## **Holyhead Port Expansion - Response to Comments on ES Addendum**

Client: Stena Line Ports Ltd

Reference: PB6108-RHD-ZZ-XX-RP-Z-0005

Date: Thursday, 25 March 2021

Figure 1 Maximum suspended sediment concentrations (mg/l) at the surface

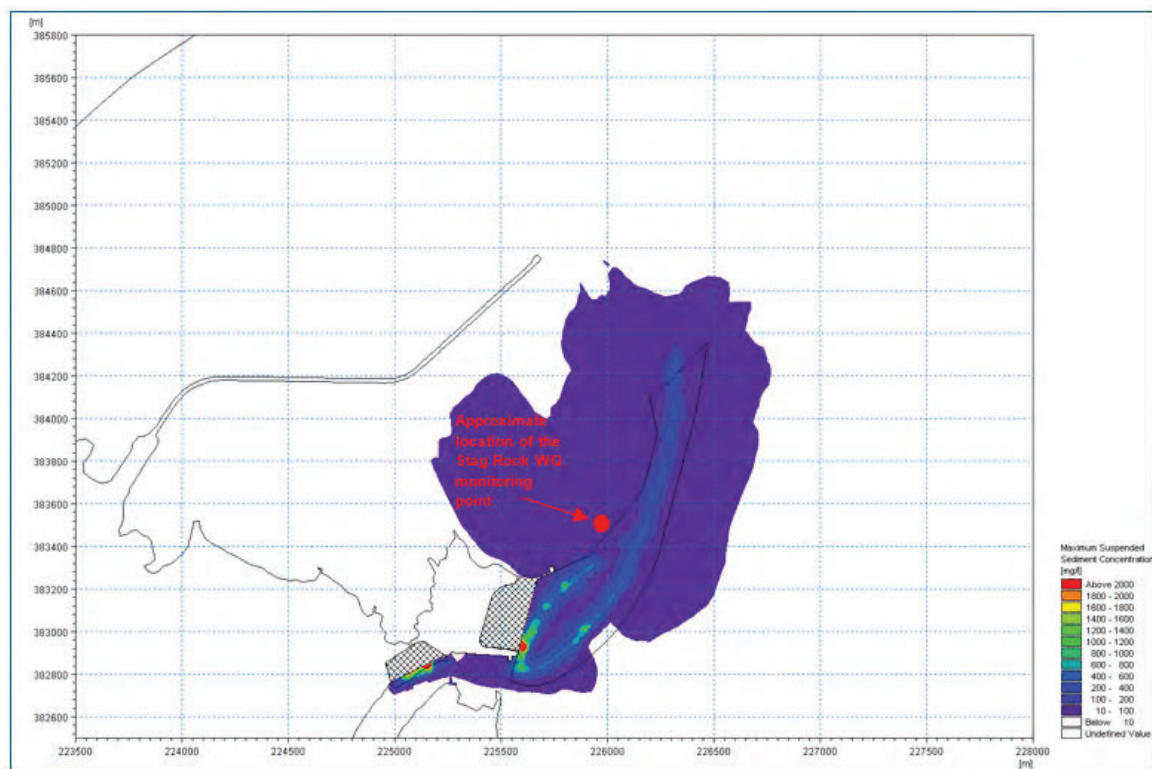
| Comment                                  | NRW Comment                                                                                                                                                                                                                                                                                                                                                                                                                                                                                                                                                                                                                                                                                                                                                                                                                                                                                                                                                                                                                                                                                                                                                                                                                                                                                                                                                                                                                                                                                                                                                                                                                                                                                                                                                                                 | Response                                                                                                                                                                                                                                                                                                                                                                                                                                                                                                                                                                                                                                                                                                                                                  |
|------------------------------------------|---------------------------------------------------------------------------------------------------------------------------------------------------------------------------------------------------------------------------------------------------------------------------------------------------------------------------------------------------------------------------------------------------------------------------------------------------------------------------------------------------------------------------------------------------------------------------------------------------------------------------------------------------------------------------------------------------------------------------------------------------------------------------------------------------------------------------------------------------------------------------------------------------------------------------------------------------------------------------------------------------------------------------------------------------------------------------------------------------------------------------------------------------------------------------------------------------------------------------------------------------------------------------------------------------------------------------------------------------------------------------------------------------------------------------------------------------------------------------------------------------------------------------------------------------------------------------------------------------------------------------------------------------------------------------------------------------------------------------------------------------------------------------------------------|-----------------------------------------------------------------------------------------------------------------------------------------------------------------------------------------------------------------------------------------------------------------------------------------------------------------------------------------------------------------------------------------------------------------------------------------------------------------------------------------------------------------------------------------------------------------------------------------------------------------------------------------------------------------------------------------------------------------------------------------------------------|
| 18                                       | <p><u>Section 3.3.2 of the ES Addendum and Chapter 9 of the original ES</u></p> <p>Impact pathways related to marine water and sediment quality are focused toward potential increases in suspended sediment concentrations (SSC). Table 3.1 of the ES Addendum (p5) notes the revised total dredge volume is 2,015,354 m3. Over a 15 week dredging programme, this will be quite intensive. Potential issues related to sediment-bound contaminants in dredge material are largely dismissed due to the results of chemical analysis from samples collected from the proposed dredge areas. While it is acknowledged that the risk is small, high SSCs are predicted due to capital dredging and, therefore, it should be demonstrated that contaminant partitioning from suspended sediment (i.e. sediment-bound to dissolved in the water column) will not result in an issue to water quality. Potential uplift should be compared to respective Environmental Quality Standards (EQS).</p>                                                                                                                                                                                                                                                                                                                                                                                                                                                                                                                                                                                                                                                                                                                                                                                             | Refer to <b>Section 2.2</b> .                                                                                                                                                                                                                                                                                                                                                                                                                                                                                                                                                                                                                                                                                                                             |

As required in the SeDiChem spreadsheet, heavy metal and TBT water quality values were averaged for each contaminant from the Holyhead Bay Stag Rock water quality monitoring point to input to the tool. This water quality monitoring point was chosen as it is located the closest to the capital dredge footprint (see **Figure 1**). The mean, maximum and minimum values for contaminants detected within vibrocore sediment samples taken between the 9<sup>th</sup> and 10<sup>th</sup> of August 2018 to inform the ES, were also used.

Figure 3 SSCs at the Holyhead Stag Rock monitoring point as a result of capital dredging activity for the approach channel. Each bar represents 5 minutes

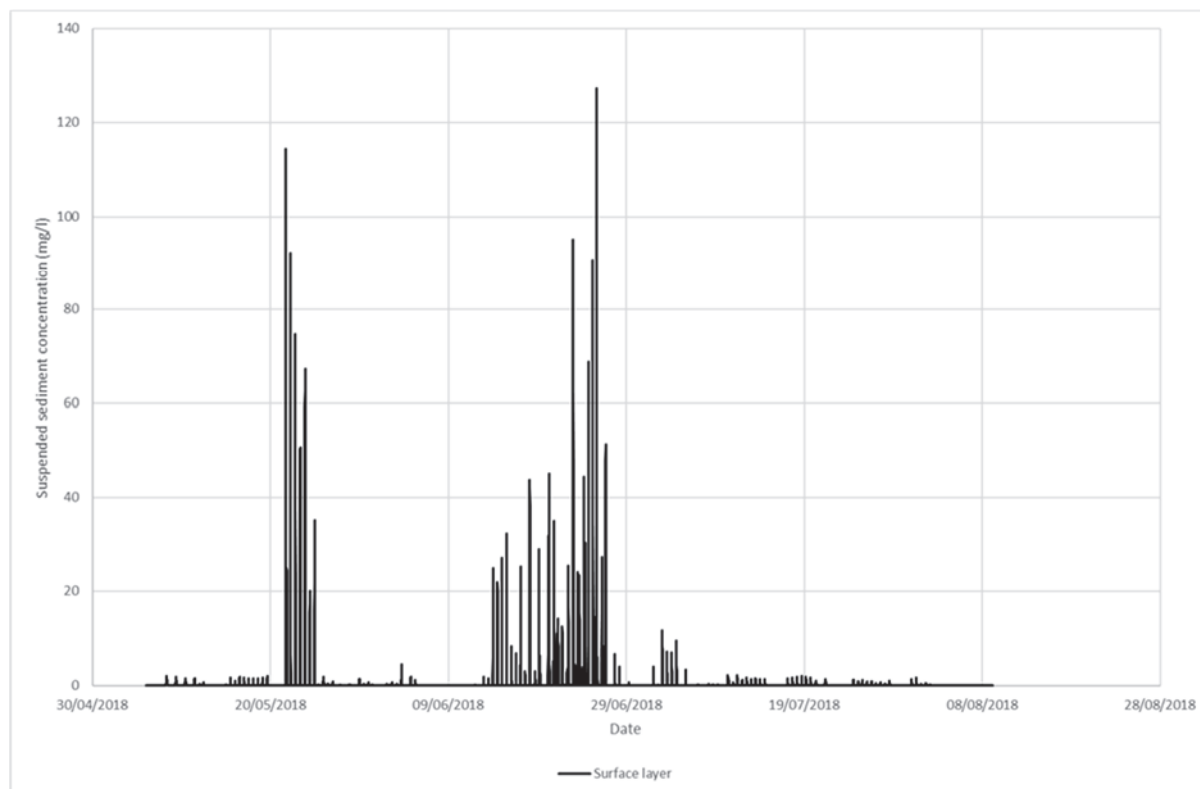
| Comment | NRW Comment                                                                                                                                                                                                                                                                                                                                                                                                                                                                                                                                                                                                                                                                                                                                                                                                                                                                                                                                                                                                                                                                                                                                                                                                                                                                                                                                                                                                                                                                                                                                                                                                                                                       | Response                      |
|---------|-------------------------------------------------------------------------------------------------------------------------------------------------------------------------------------------------------------------------------------------------------------------------------------------------------------------------------------------------------------------------------------------------------------------------------------------------------------------------------------------------------------------------------------------------------------------------------------------------------------------------------------------------------------------------------------------------------------------------------------------------------------------------------------------------------------------------------------------------------------------------------------------------------------------------------------------------------------------------------------------------------------------------------------------------------------------------------------------------------------------------------------------------------------------------------------------------------------------------------------------------------------------------------------------------------------------------------------------------------------------------------------------------------------------------------------------------------------------------------------------------------------------------------------------------------------------------------------------------------------------------------------------------------------------|-------------------------------|
| 26      | The Holyhead Bay coastal water body is currently (2018) classified as failing chemical status, specifically the parameters Fluoranthene, Benzo(a)pyrene, Mercury and its compounds and Trichlorobenzene. With the above WFD classification in mind, it is necessary to demonstrate the scale of any uplift during the proposed activities. It may be possible to show that the predicted uplift in contaminant levels, in particular those currently failing to achieve good, in the water column would be so small (and short-lived) to result in no discernible change at the water body level. This could use the maximum contaminant concentration in the dredge material, predicted increased SSCs and partition coefficients to estimate the increase in dissolved concentrations.                                                                                                                                                                                                                                                                                                                                                                                                                                                                                                                                                                                                                                                                                                                                                                                                                                                                          | Refer to <b>Section 2.2</b> . |

To provide a clearer understanding of real time SSCs, **Figure 3** presents the modelled SSC data from the Stag Rock monitoring point as a time series. This provides additional information regarding the behaviour of the plume and shows that in reality the maximum SSCs shown in **Figure 2** are not continuous and are very short-lived. Peaks in SSC are experienced when the dredger passes close to the monitoring point and then reduce to within background levels within 30 minutes following cessation of the dredging activity, when the dredger is sailing to the disposal site. As requested by NRW in their email of the 8<sup>th</sup> March 2021, further time series plots from within the dredger path are presented in **Appendix F** to provide further understanding of the temporary nature of the peaks in SSC.

The predicted peak SSC value at the monitoring point is 127mg/l, however SSCs above 100mg/l only last for a total of 10 minutes over the length of dredging activity (15 weeks) (**Figure 3**). For the majority of the dredge campaign, SSCs are therefore predicted to be within baseline levels (5.9mg/l, ES Appendix D) and the average increase in SSC experienced at the monitoring point over the length of the dredging activity is only 0.57mg/l.

To run the tool, a SSC of 50mg/l was used to reflect an approximate average of the peak concentrations experienced at this location which significantly exceed baseline concentrations, as shown in **Figure 3**.

| Figure: 4 | Drawing No: PB6108-108-400 |

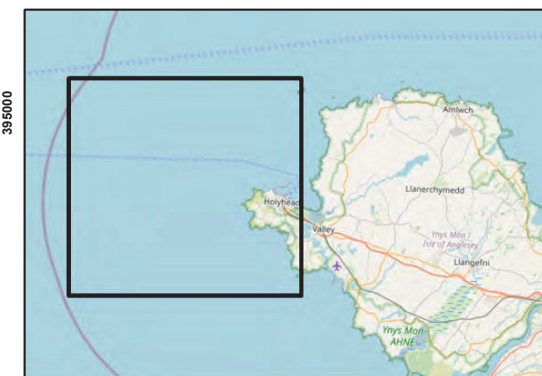
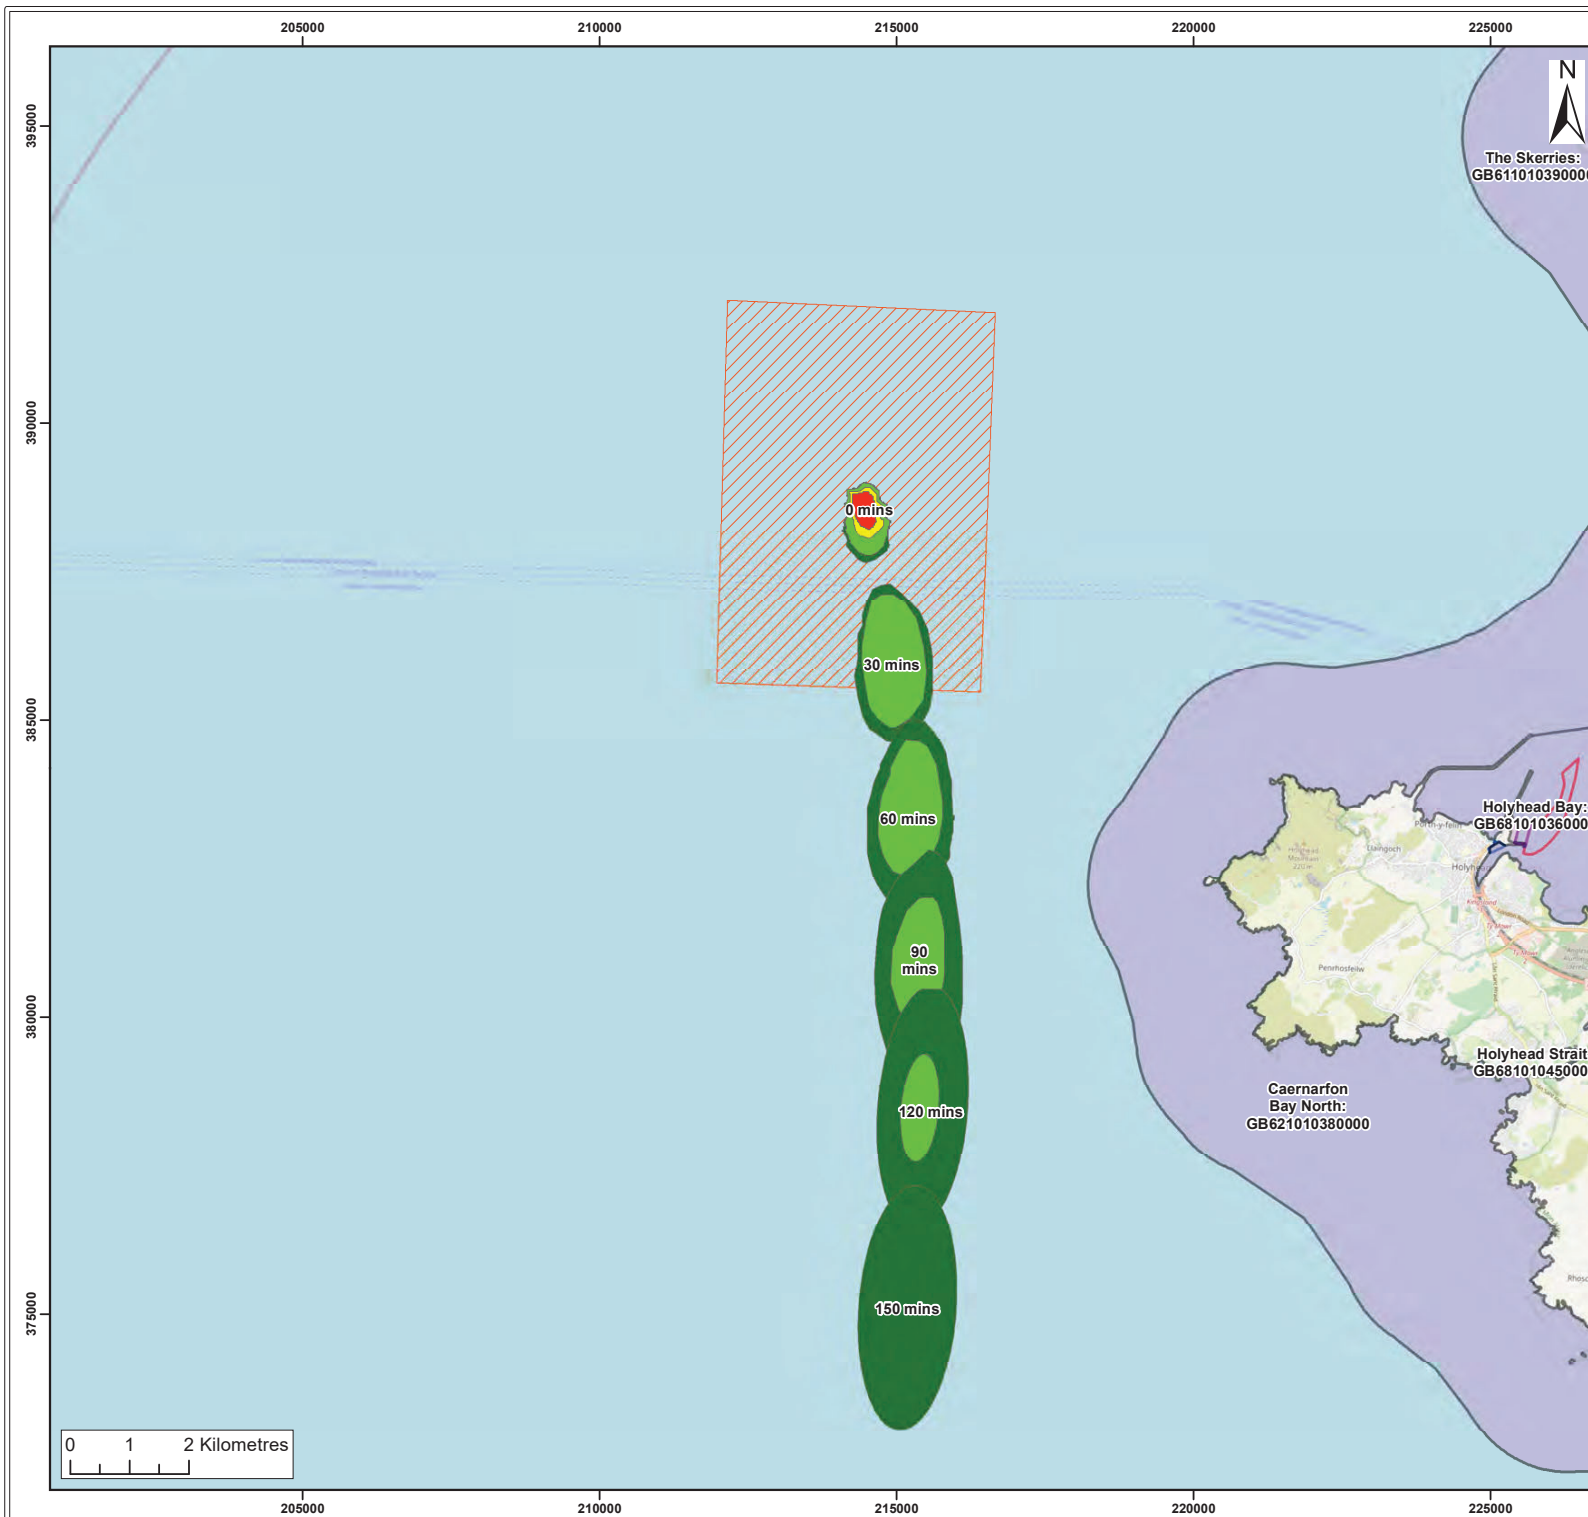
| Comment | NRW Comment                                                                                                                                                                                                                                                                                                                                                                                                                                                                                                                     | Response                                                                                                                                                                                                                                                                                                                                                                                                                                                                                                                                                                                                                                                                                                                                                                                                                                                                                                                                                                                          |
|---------|---------------------------------------------------------------------------------------------------------------------------------------------------------------------------------------------------------------------------------------------------------------------------------------------------------------------------------------------------------------------------------------------------------------------------------------------------------------------------------------------------------------------------------|---------------------------------------------------------------------------------------------------------------------------------------------------------------------------------------------------------------------------------------------------------------------------------------------------------------------------------------------------------------------------------------------------------------------------------------------------------------------------------------------------------------------------------------------------------------------------------------------------------------------------------------------------------------------------------------------------------------------------------------------------------------------------------------------------------------------------------------------------------------------------------------------------------------------------------------------------------------------------------------------------|
| 21      | <p>Section 4.3.2 of ES Addendum (p50-51) - Time-series plots of SSC dissipation (Fig 4.10 and 4.11) show the plume in the mid-layer moving south following cessation of dredging, well outside of the Holyhead North disposal site boundary. Clarification is sought on the fate of the plume. We recommend that bathing waters and shellfish waters are included and assessed in relation to the plume along with wastewater and contaminants.</p>                                                                             | <p>Refer to <b>Section 2.3</b>.</p>                                                                                                                                                                                                                                                                                                                                                                                                                                                                                                                                                                                                                                                                                                                                                                                                                                                                                                                                                               |
